UNITED STATES PATENT AND TRADEMARK OFFICE

APPLICATION NO.	FILING DATE	FIRST NAMED INVENTOR	ATTORNEY DOCKET NO.	CONFIRMATION NO.
10/530,077	09/22/2005	Marcos Giovanni Bortoli	04306/0202707-US0	7459
7278 7590 02/10/2011 DARBY & DARBY P.C. P.O. BOX 770 Church Street Station New York, NY 10008-0770				
EXAMINER KASTURE, DNYANESH G				
ART UNIT		PAPER NUMBER		
3746				
MAIL DATE		DELIVERY MODE		
02/10/2011		PAPER

Office Action Summary

DETAILED ACTION

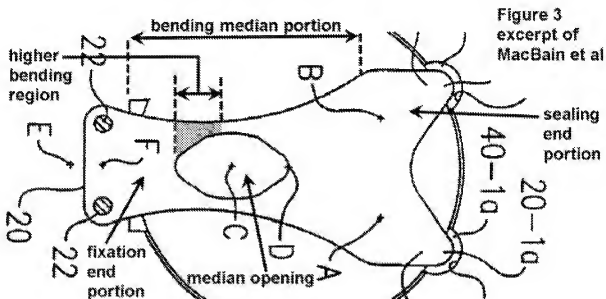
6. In Re Claim 10, the phrase "a substantially semi-elliptical contour with its vertex being tangent with the fixation end portion" is indefinite due to the following: When an element is referred to as being tangential with an object (fixation end portion), the element is usually a curve or a surface or a line; but it never is a POINT - which is what "vertex" is as referred to in the claim. How can a point (vertex) be tangent to anything ? Even if an imaginary line was drawn demarcating the border between the higher bending region and the fixation end portion, it is this line that would be tangential to the semi-elliptical contour (at the vertex). THE POINT OF CONTACT between this line and the contour would be the vertex.

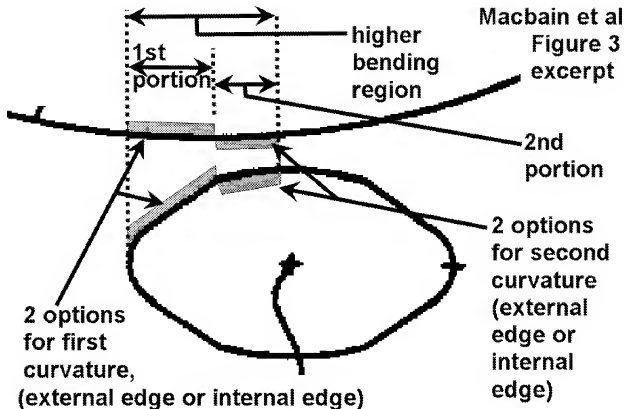
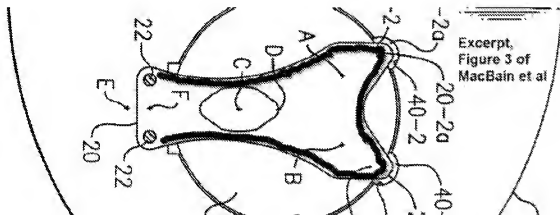
9. In Re Claim 10, with reference to Figure 3 annotated above, MacBain et al discloses a suction valve for a small hermetic compressor (Abstract states "compressor suction valve") of the type presenting a compression cylinder (D) which has an end closed by valve plate (30), said valve comprising:

- a fixation end portion (annotated) to be affixed to the valve plate;
- a bending median portion (annotated) provided with a median opening (annotated) aligned with a discharge orifice (see Figure 1); and
- a sealing end portion (annotated) operatively associated with the suction orifice provided in the valve plate,

- a higher bending region (as annotated by the shaded area, the width of which decreases along the higher bending region) of the flexible vane of the valve

- a first portion of the higher bending region as depicted above, bounded by at least one curved edge (first curvature) represented by the external edge of the flexible vane; (the shaded rectangles in the annotated first and second portions above highlight the options for the first and second curvatures)

- a second portion of the higher bending region as depicted above, bounded by the curved external edge and curved internal edge (second curvature)
- the claim limitation of the distance between an external edge of the flexible vane and its adjacent internal edge portion of the median opening diminishes more rapidly in a first portion, is anticipated by the steep decline in the first portion when compared to the gradual decline in the second portion; from a maximum value close to the end fixation portion, to a minimum value, close to the boundary of the higher bending region of the flexible vane,

- wherein the flexible vane is configured to distribute opening forces along the higher bending region (no areas of stress concentration) allowing the flexible vane to be bent along the higher bending region in an open position, and

**Excerpt,
 Figure 3,
 MacBain et al**

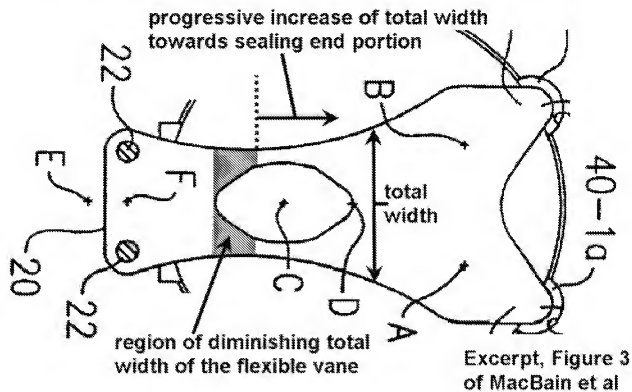
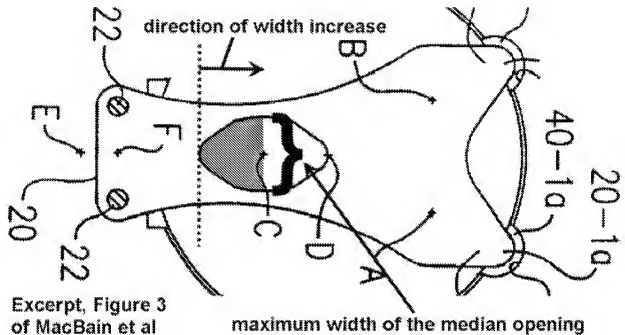
- the bending median portion and sealing end portion “presents” a U shape as annotated below, with the legs being symmetrical about a longitudinal axis of the flexible vane, are of equal length and are united by the fixation end portion as depicted:

(Note that the limitation "presenting" could also be broadly interpreted as enclosing a U shape, since the outline is not being claimed as U shaped. Further, the "united by" limitation could be interpreted as bringing the two legs together.)

- wherein the median opening of the valve presents, along the higher bending region, a substantially semi-elliptical contour (the curved boundary of the shaded area in the annotated figure above is substantially semi-elliptical), and as best understood, "its vertex being tangent with the fixation end portion "

- wherein the width of the median opening of the flexible vane increases, progressively (see annotations above), from a region adjacent to the fixation end portion (22) to at least the opposite boundary of the higher bending region, whereas the total width of the flexible vane diminishes from the fixation end portion, at an initial portion (see shaded area and annotations above), and then it begins to progressively increase as depicted towards the sealing end portion, from before the opposite boundary of the higher bending portion
